HERITAGE IMPACT STATEMENT (PROPOSED MODIFICATION TO JULIETTE BALCONIES) | SIRIUS BUILDING, 2-60 CUMBERLAND ST, THE ROCKS (SSD 10384)

Subject: Juliet balcony hydraulic drainage compliance

**Re: Juliette Balconies Balustrade
2-60 Cumberland Street, The Rocks**

DETAILS - PODS - WINDOW
SECTIONS

2 40G - DETAIL - SECTION - WINDOW SILL - BALCONY TO EXISTING
1:5

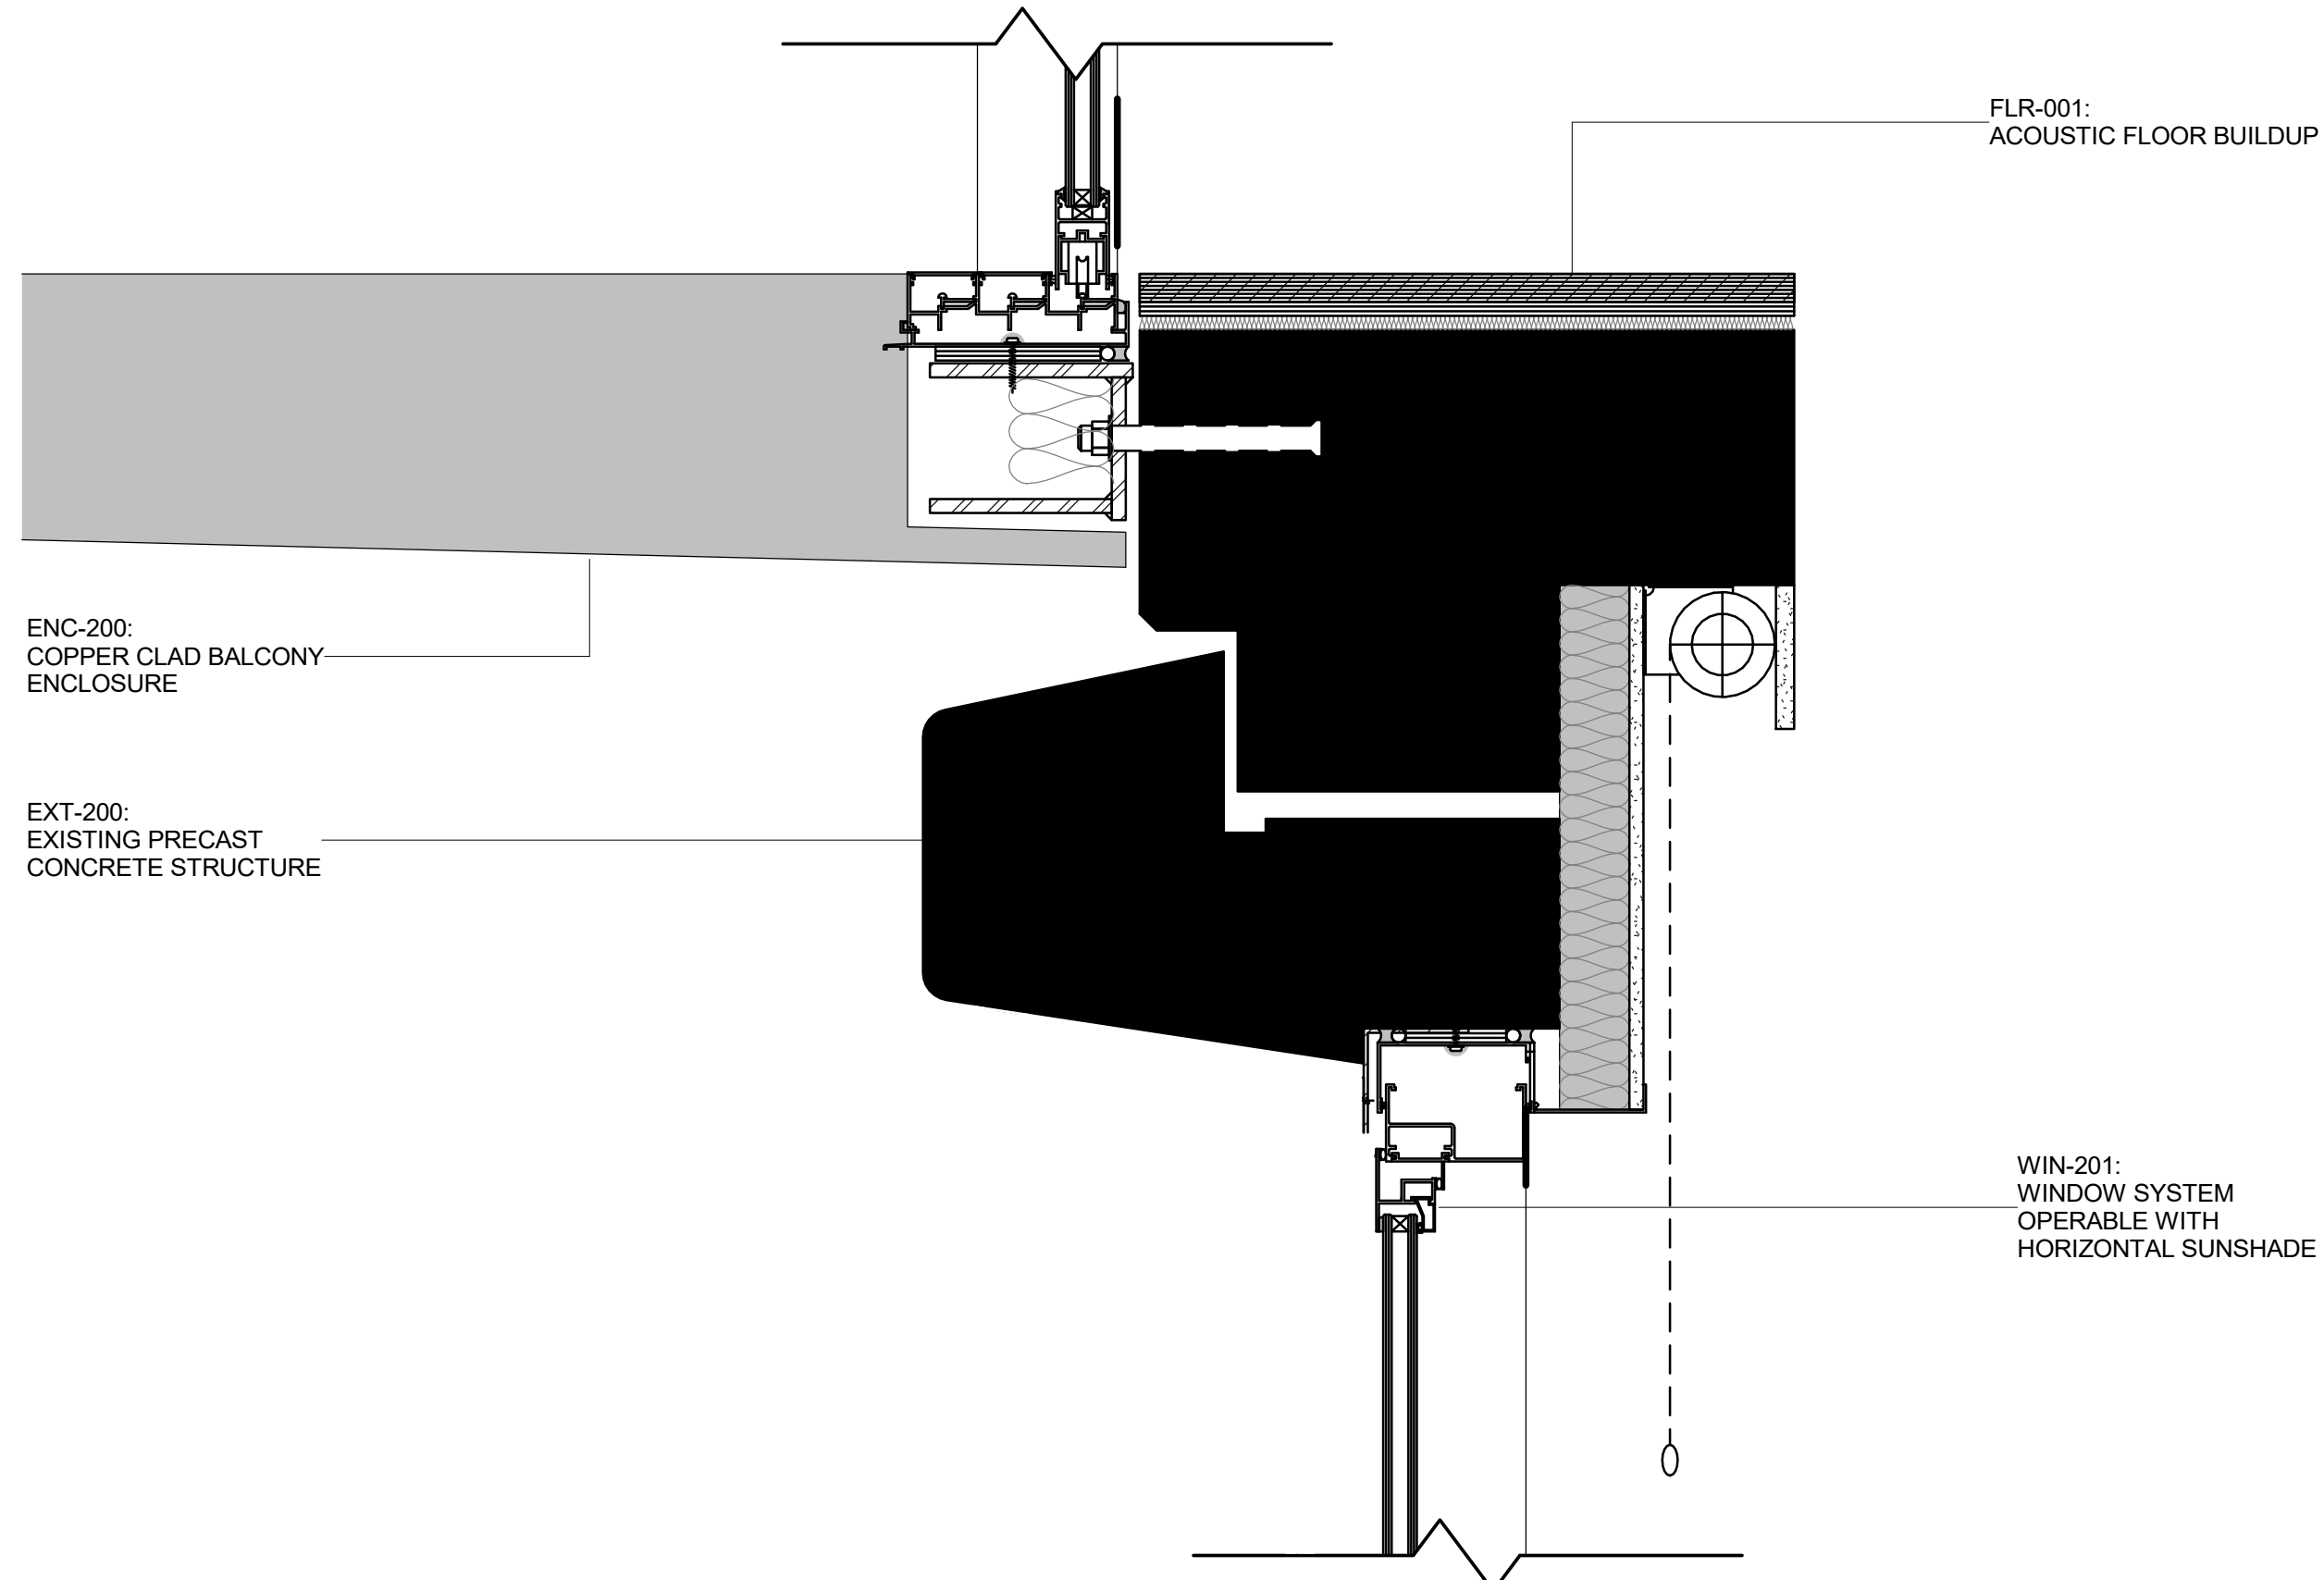
1. We understand that window sill detail is required to be amended as detailed in drawing 40G-LXX-232(3) for weatherproofing and to comply with BCA 2019 Amendment 1 FP1.4.
2. In accordance with BCA 2019 Amendment 1 D2.24, where the lowest level of the bedroom window opening is less than 1700mm above finished floor level, the window opening needs to be restricted to 125mm.
3. We also note requirements from the Strata Schemes Management Regulation that requires the openings to be restricted to 125mm for all windows below 1.7m sill height in the building (not just bedrooms) where the floor below the window is more than 2m above the surface beneath.
4. Level 9 and 11 balcony design, as detailed in Section 3 of drawing AR-40G-LXX-242(2), would require the sliding door to be restricted to 125mm to comply with the requirements of BCA 2019 Amendment 1 D2.24(a) and (b).
